intel® Technical Advisory

TA-0819-00

Intel® Server RAID Controller SRCU42E Memory DIMM Fails with Corrupted Cache Message During POST or Operating System Installation.

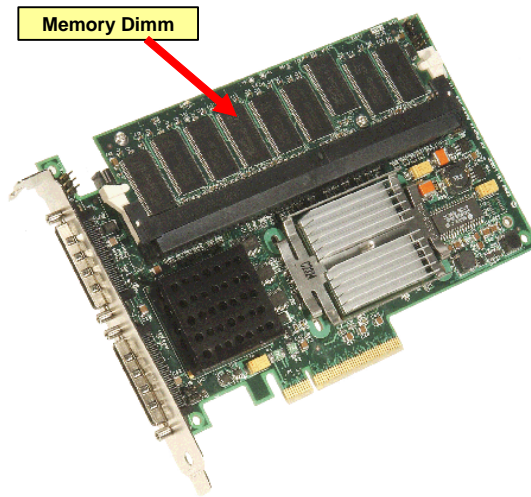
Customers should return affected controllers through the normal warranty process. A limited supply of replacement controllers is currently available and an additional supply of controllers will be available in the warranty depots on or before August 18th, 2006. For Warranty requests for this issue, please indicate that you are calling regarding TA-0819-00, and have the serial number for each affected RAID controller available when you call. Affected controllers can be identified by checking the memory module part number as depicted below:

1. The graphic below identifies the location of the memory model on the SRCU42E RAID controller:

2. The affected Virtium Part Number is VM381L1624-B3SF, the graphic below illustrates how to identify the affected memory module.
